State Significant Development 7664

Horsley Drive Business Park Stage 2
Section 4.55(2) Modification Application

Submitted to Department of Planning and
Environment
On behalf of Charter Hall

27 March 2020 | 7190880

Figure 1 Approved Horsley Drive Business Park Stage 2 – Indicative Masterplan WS-HW-MP-005

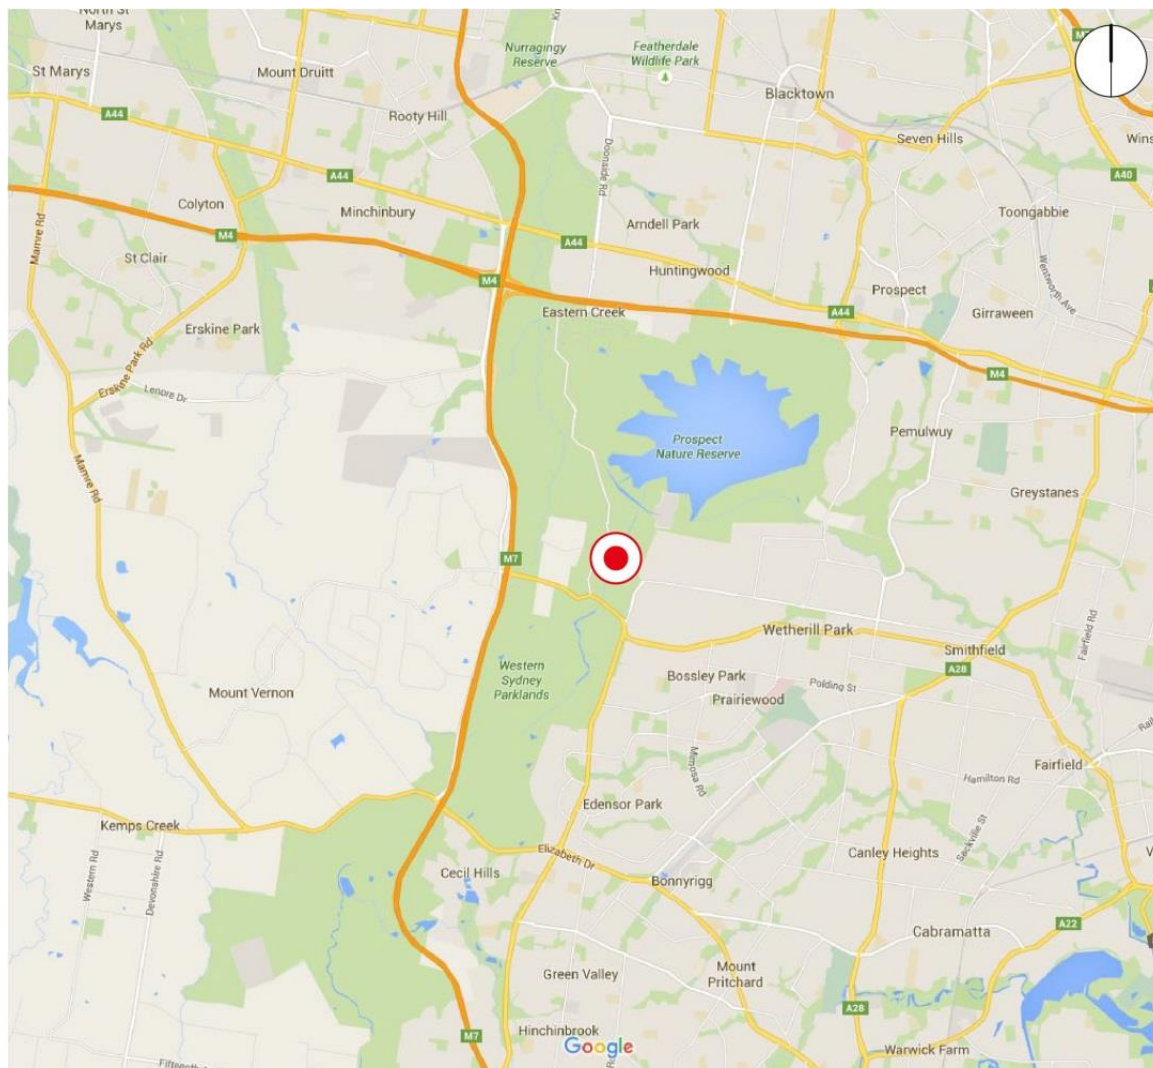
The approved Concept Plan Indicative Masterplan is shown in **Figure 1** below.

Whilst the Concept Proposal envisaged two warehouse developments in the southern portion of the site, the proposed Customer Fulfilment Centre has a need for a larger floorplate, necessitating a specific functional layout requirement for this portion of the site and as a result a modification to the approved masterplan.

This Section 4.55(2) application aims to modify the Concept Plan and Stage 1 earthworks approval (SSD 7664) to align the proposed development of the Stage 2 (Building 1) Customer Fulfilment Centre.

Figure 8 Overall Site Plan

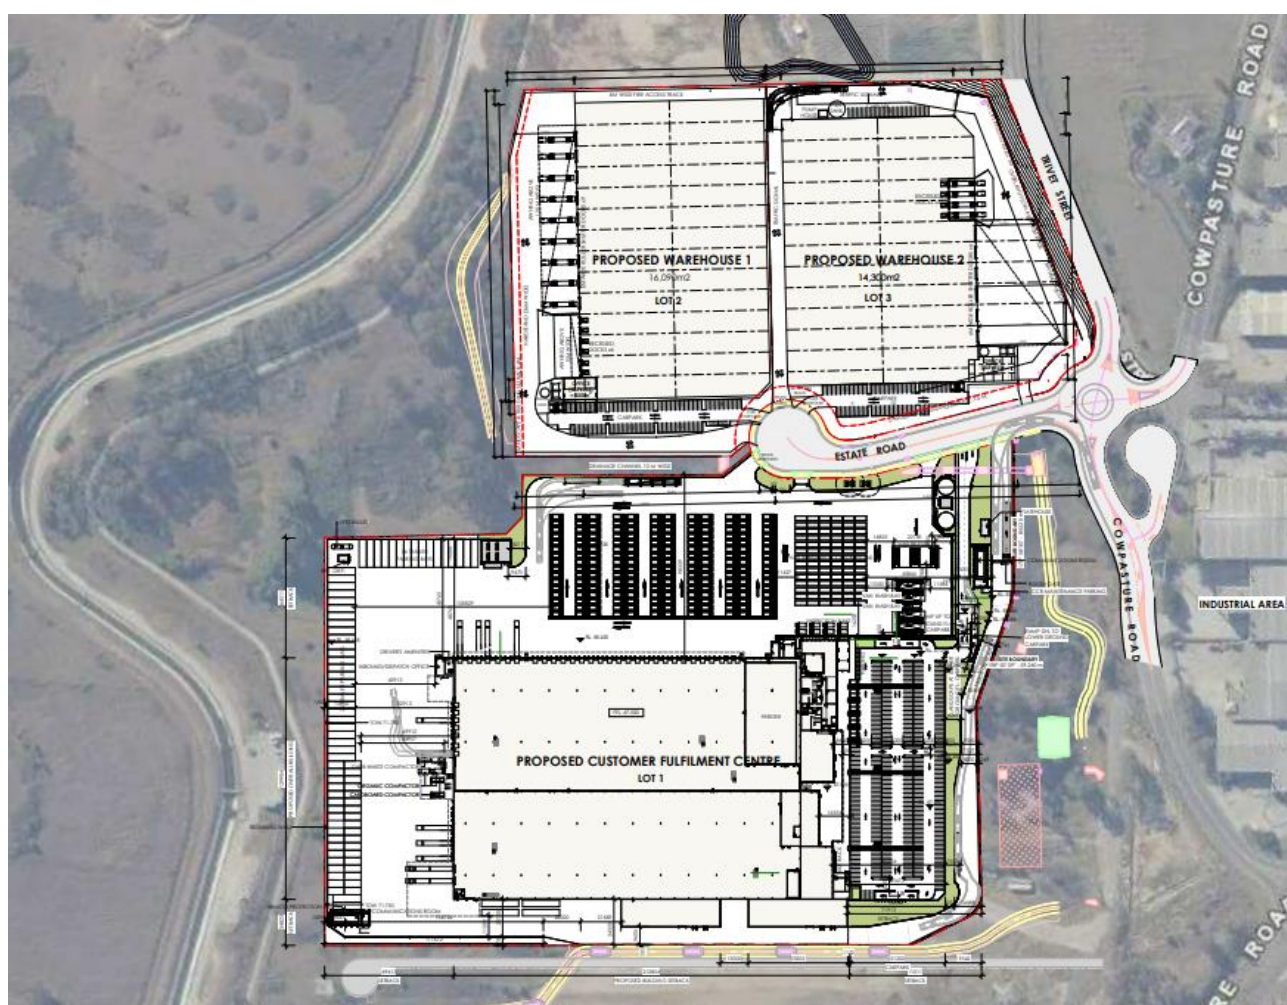
The proposed modification to the SSD 7764 Concept Approval comprises the following:

- A revised location and configuration for vehicular access to the site, including provision of an access roundabout intersection with Cowpasture Road and Trivett Street;

- An increase in the total number of carparks provided from 397 (approved) to 672 (proposed);
- Provision of a Customer Fulfilment Centre (CFC) on southern lot to replace Warehouse 1 and 2. The CFC will be a specialist warehouse facility used for the distribution of goods. The northern lots would accommodate traditional warehouse development;

- Alterations to the finished development levels on the site; and
- Alterations to the landscaping to align with the revised lot and built form configuration.

The proposed modification to the concept approval is shown in **Figure 8** and the proposed modification to the approved subdivision plan is shown in **Figure 9** below.
